STAFF REVIEW AND RECOMMENDATION

Variance Case #: V2016-05 **Legistar #:** 20160072
Board of Zoning Appeals Hearing: Monday, February 29th, 2016 – 6:00 p.m.
Property Owner: Voyles Family Partnership LLLP & C/O FSSR
Valery Voyles
2103 Cobb Parkway S
Marietta, GA 30067
Applicant: Same as above
Address: 2103 Cobb Parkway South
Land Lot: 781 **District:** 17 **Parcel:** 0050
Council Ward: 7A **Existing Zoning:** CRC (Community Retail Commercial)

Re: Ed Voyles Honda – Variance Request
2103 Cobb Parkway S.E.
Atwell Project No. - 15001548

PRO BUILDING SYSTEMS, INC.
ED VOYLES HONDA
SITE DEVELOPMENT PLANS
SITE PLAN

DRAWN BY: R.J.P.
CHECKED BY: B.E.K.
PROJECT MANAGER: B.E.K.
JOB #: 15001548
FILE CODE: ##
SHEET NO. C200

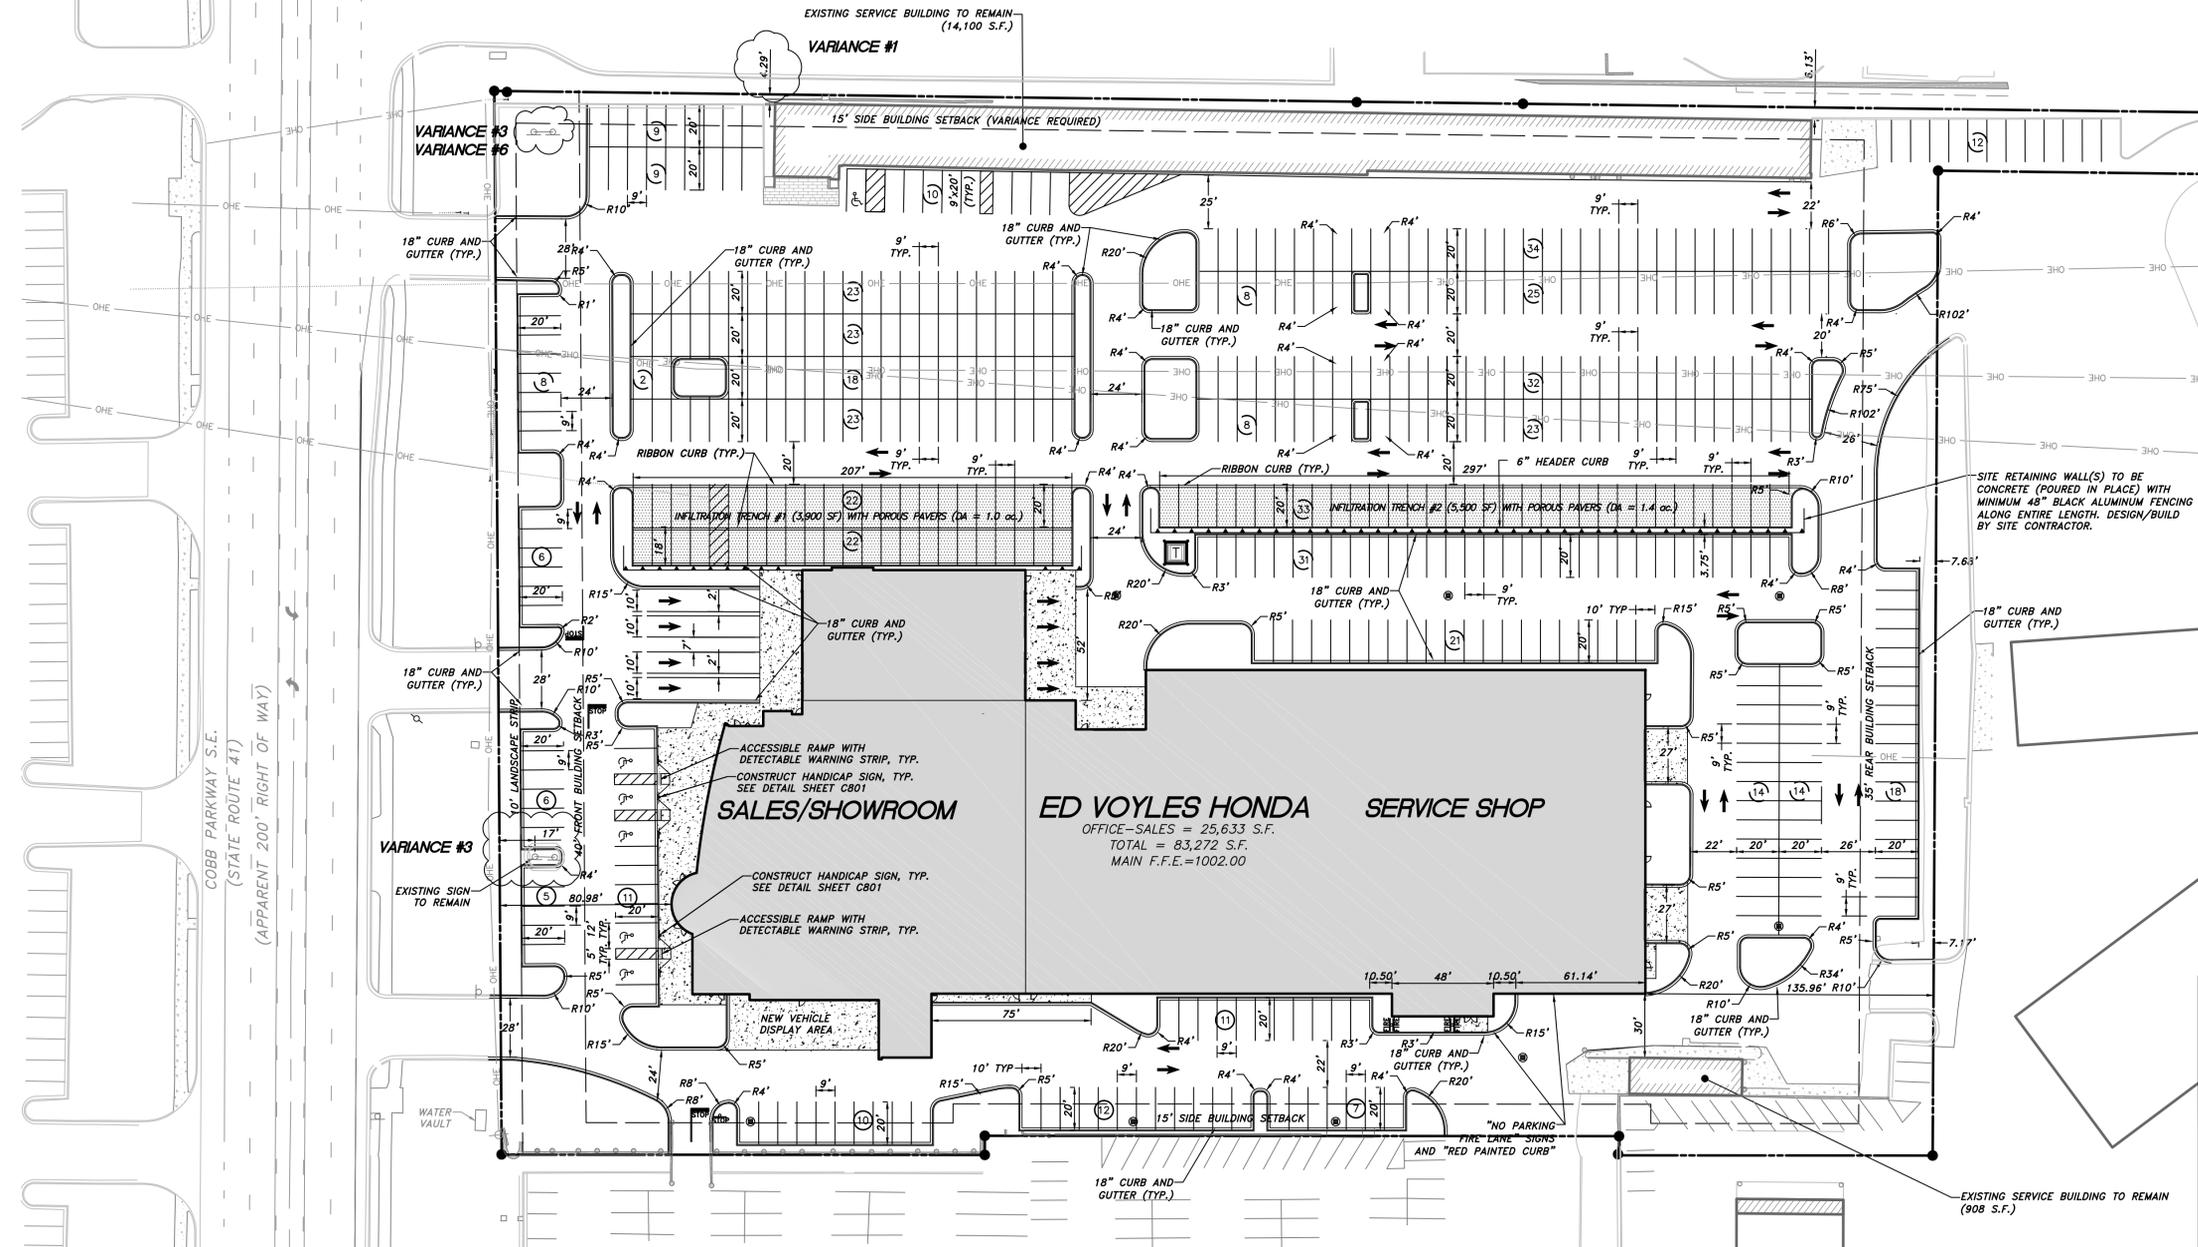
The existing monument sign on the southern side of the property advertises the Honda brand, is 25 feet tall, contains approximately 64 (8'x8') square feet of sign area, and approximately 136 (17'x8') square feet of structure. The used car sign is currently a nonconforming pylon sign located at the northwest corner of the parcel, near Cobb Parkway South. The applicant wishes to convert this sign to monument style but keep the existing height of approximately 20 feet. This will result in a sign structure area over the allowed 90 square feet, upwards of 180 total square feet for structure only.

Other dealerships have complied with the sign regulations during such renovations, and have built new compliant signs. Because this applicant has provided no hardship to justify why their sign cannot be updated to comply with the same codes applicable to other businesses, **staff recommends denial of this variance.**

The property contains a narrow, but long building along the northern side of the property. The applicant is not proposing any changes to the building and is requesting a variance to allow it to remain 4' from the side property line instead of the required 15.' The Marietta Fire Department has no objections with the building remaining in its existing location with the stipulation that, if any modifications to the structure are conducted, the structure must comply with 'new' for the occupancy classification which it is assigned. Being that there are no safety concerns with the placement if the existing building along the northern property line, **staff recommends approval of this variance request.**

According to the submitted plan, the impervious surface coverage for the existing site is 98%. The modifications included in the project, namely the inclusion of numerous tree islands and border areas, will result in a lower impervious surface coverage (88%) of the site, but not as low as required by CRC, which is 80%. Car dealerships are often heavily paved in order to store the cars. However, the zoning ordinance does not exempt car dealerships or hold them to a lower standard due to the nature of the business. They are expected to adhere to the same regulations as other businesses operating in the same zoning district. **As a result, staff recommends denial of this variance request.**

The plans that have been submitted show that the applicant will provide substantially more landscape areas than currently exist. However, this variance is linked with the impervious surface coverage request in that very few pervious areas allow very few opportunities to plant trees, which not only improve the aesthetics but also aid with stormwater runoff. The project will also include some areas of pervious pavers. The applicant has stated that, aside from the reduction in the landscaped area, the intention is to comply with the rest of the Tree Protection and Landscaping ordinance, including tree density. Any tree density not able to be provided on site will be paid into the Tree Replacement Fund. However, the zoning ordinance does not exempt car dealerships or hold them to a lower standard due to the nature of the business. They are expected to adhere to the same regulations as other businesses operating in the same zoning district. **As a result, staff recommends denial of this variance request.**
